VALUE ENGINEERING REPORT

SR 124 / US 78 Continuous Flow Intersection
CSSTP-0006-00(439), PI No. 0006439
Gwinnett County

April 29, 2010

Idea No.: A-5
Client: GDOT
Sheet 2 of 4

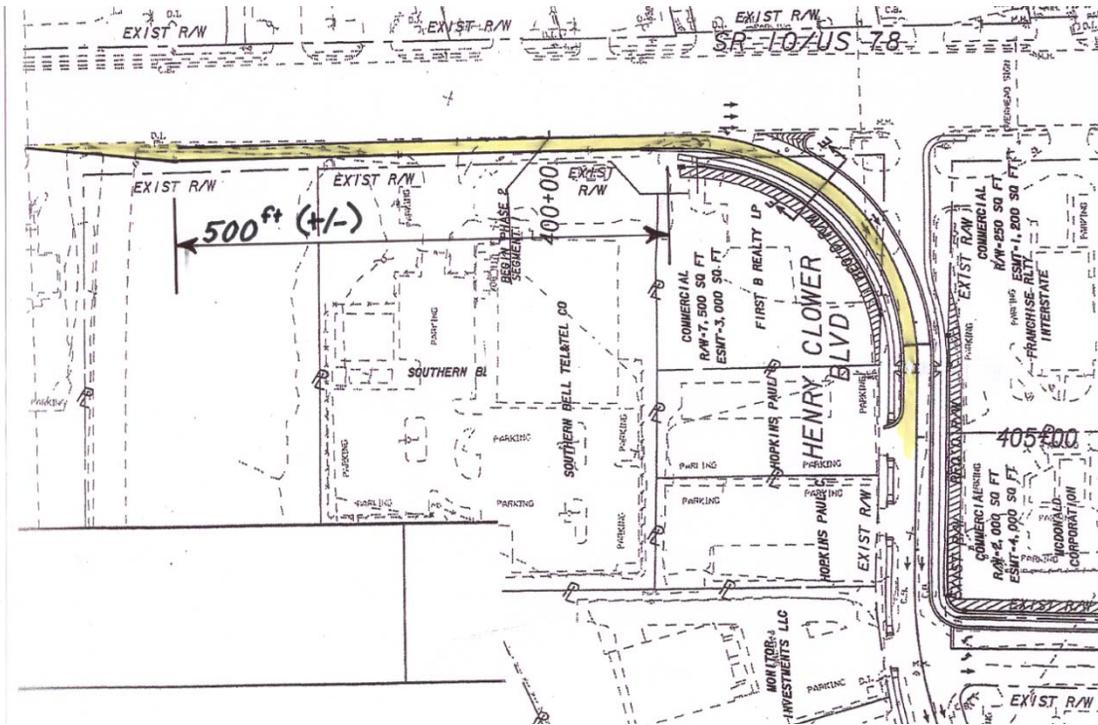
The current project includes a new eastbound US 78 dual right turn exit to Henry Clower Boulevard. The current design does not include any dedicated deceleration lane / bay to accommodate the first right turn at the dual exit curves.

It is recommended that a dedicated right turn deceleration lane / bay be constructed to provide a smooth transition into the first exit curve at Henry Clower Boulevard. The deceleration lane should be approximately 500 feet long and appropriately signed.

Idea No.: A-8
Client: GDOT
Sheet 2 of 4

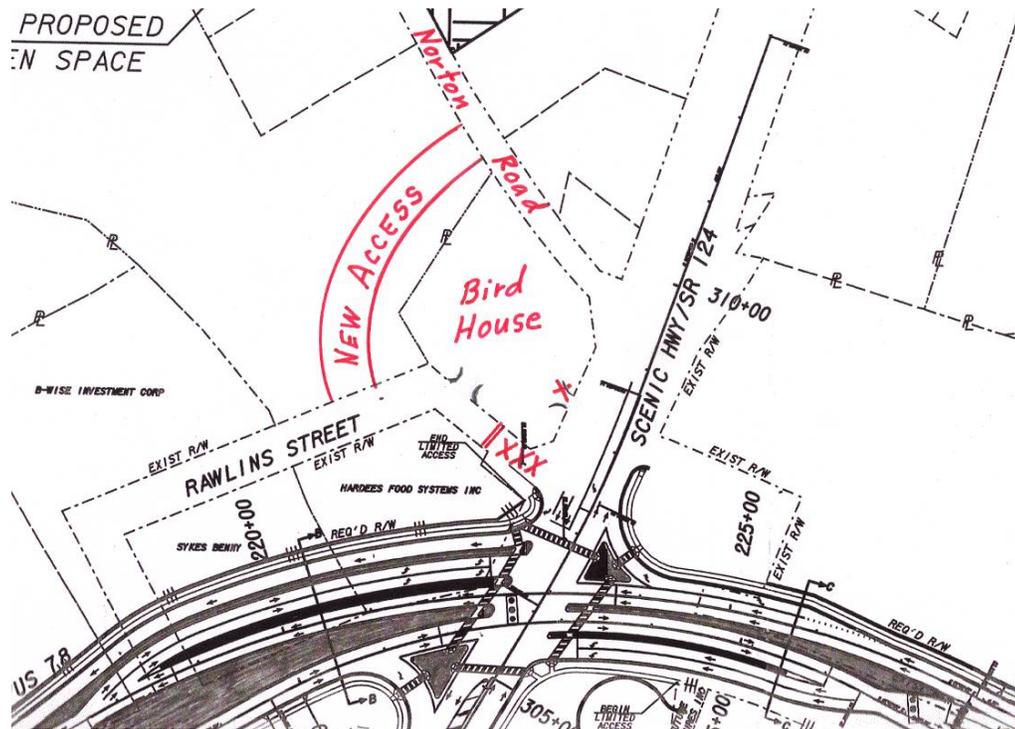
The current design allows two access openings on the northwest side of SR 124 in the north leg of the CFI. The first opening is for Rawlins Street which serves the Shell Richard, B Wise Investment Corporation, (2) Buisson, and the Bird House properties. The second opening is for the Bird House. These access openings tie directly into where the proposed direct flow right turn lane curves toward westbound US 78.

It is recommended that the SR 124 / Rawlins Street and SR 124 Bird House access openings be closed and new access be provided via Norton Road.

Idea No.: A-12

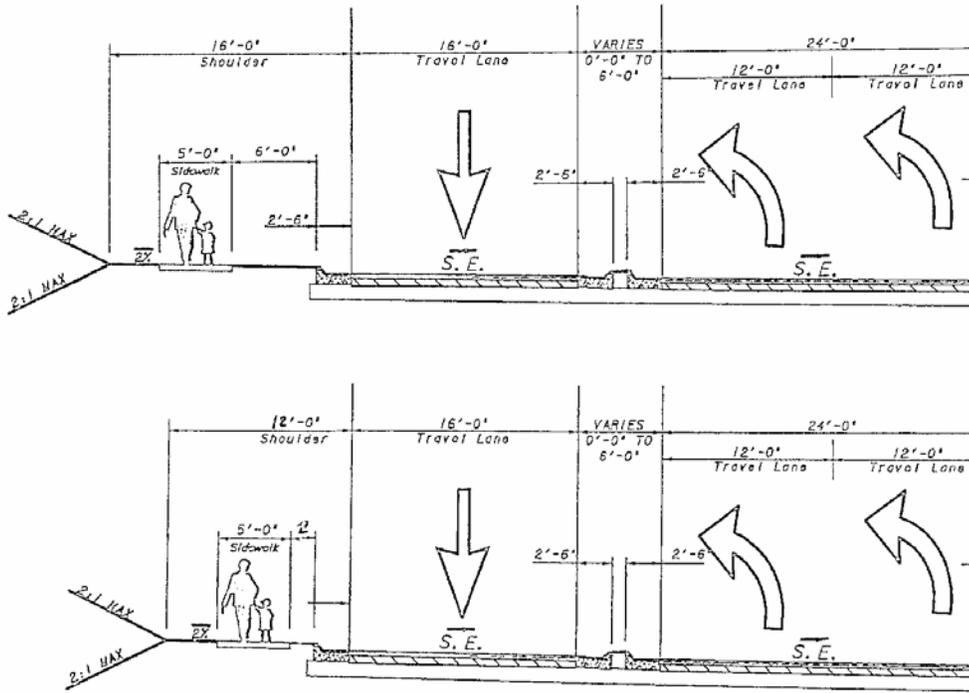
The current roadway typical section includes a 16-foot wide outside shoulder. The shoulder width includes a 30-inch curb & gutter, a 6-foot grass area between the sidewalk and the back of curb, a 5-foot sidewalk, and an 18-inch outside grass area. The current CFI design requires significant R/W and closes access to several local businesses.

It is recommended that the shoulder width be reduced from 16 feet to 12 feet on the north side of the CFI and at the new right turn lanes on Henry Clower Boulevard.

Idea No.: A-2
Client: GDOT
Sheet 3 of 7

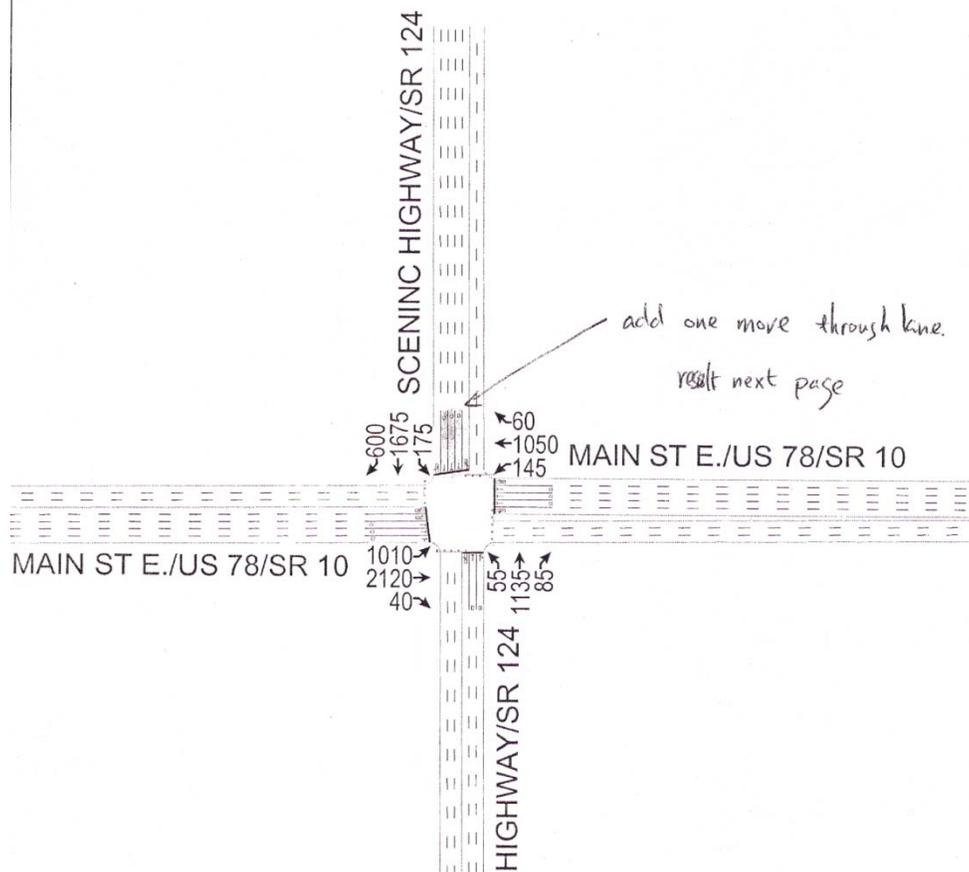
The US 78 / SR 124 intersection is poorly oriented for a CFI. It has a sharp 30 (+/-) degree skew angle requiring the west side of the intersection to be constructed with a large curve, complicating its operation. The CFI contains only four US 78 through lanes that may require future modifications as US 78 is widened to six lanes east of this intersection. The VE team is

Proposed Change: This recommendation would make more conventional changes to the US 78 / SR 124 intersection. The changes would add additional through lanes to both routes to improve capacity and LOS. One through lane would be added in each direction on US 78 and one southbound through lane would be added to SR 124. The current double eastbound US 78 to northbound SR 124 left turn lane would be maintained. The recommended widening will have to avoid the project constraints however a more detailed alignment study should be developed to completely analyze the impacts.

Idea No.: B-3
Client: GDOT
Sheet 2 of 6

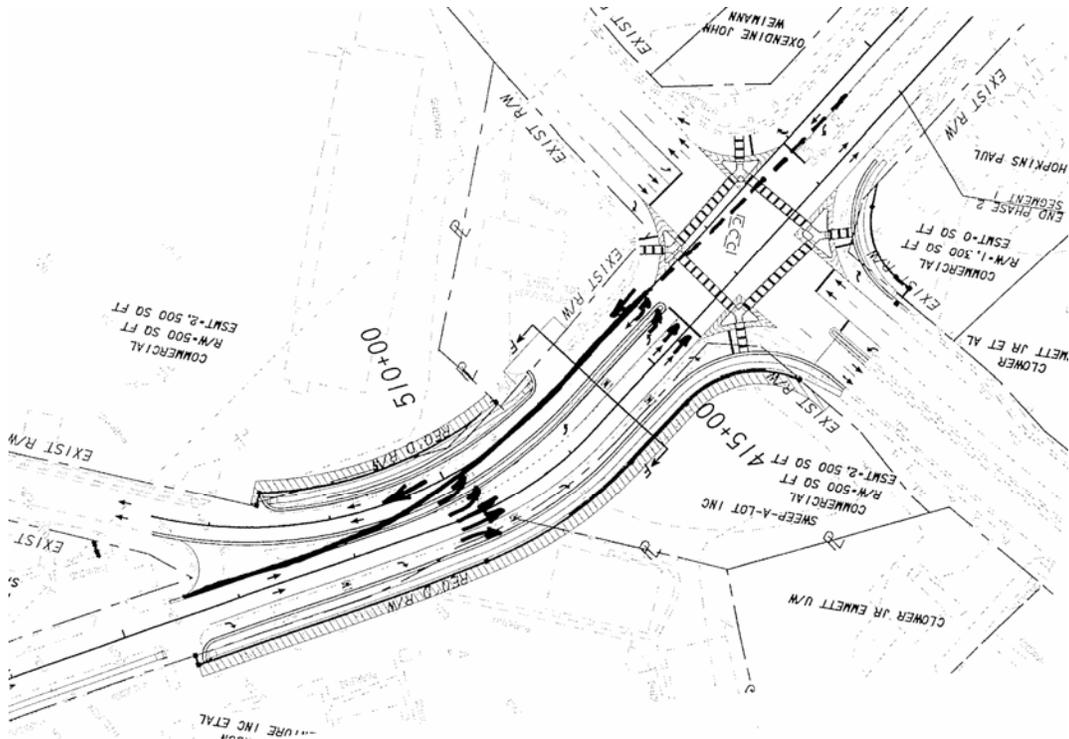
The original concept requires extensive reconstruction and R/W impacts to construct the CFI at the SR 124/US 78 intersection. The VE concept implements a “jug handle” design to move the heavy left turn movement away from the conflicting heavy through movements on US 78. The minimal opposing through movements on Henry Clower Boulevard and the reduced southbound SR 124 through volumes will allow this intersection to facilitate the heavy left turn volumes in a more efficient manner. The removal of the US 78 left turn movement phase and increased US 78 capacity will allow the SR 124/US 78 intersection to operate more efficiently.

Proposed Change: This recommendation would eliminate the US 78 left turn movements at its intersection with SR 124. Westbound left turn movements would be relocated to the US 78 / Oak Road / Henry Clower Boulevard intersection. Eastbound left turn movements would be relocated to the Henry Clower Boulevard / SR 124 intersection (providing a jug handle concept). Eastbound Henry Clower Boulevard would be reconfigured to provide for dual left turns at SR 124.

Idea No.: A-11

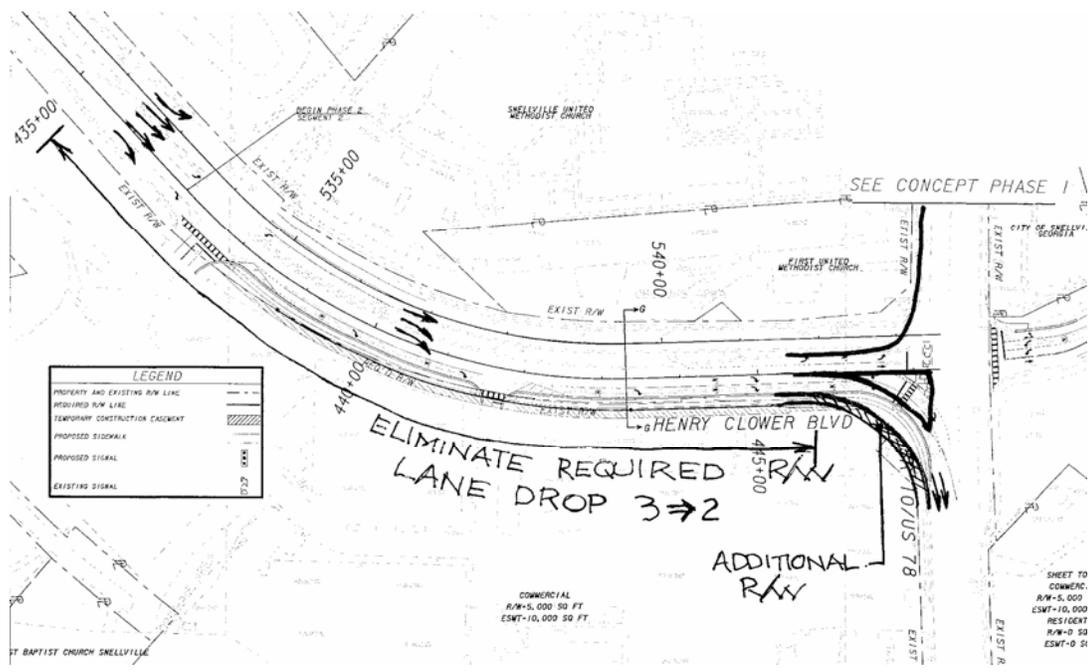
Justification: Converting to a one-way pair alignment would eliminate the Phase 1 CFI portion of the project resulting in significant cost savings. One-way pair alignments are used in many downtown areas and can be applied here. While this concept would result in a major change in traffic and access patterns, it would improve all signal and intersection operations. A one-way traffic pair would simplify pedestrian crossings and help develop more of a “downtown feel” for Snellville. This concept will require advance signing to inform motorists of the change to a one way pair.

Proposed Change: It is recommended that only Phase 2 (Henry Clower Boulevard By-pass) be constructed at this time and the roadway network be converted into a one-way pair alignment thereby eliminating the need to construct Phase 1 (CFI).
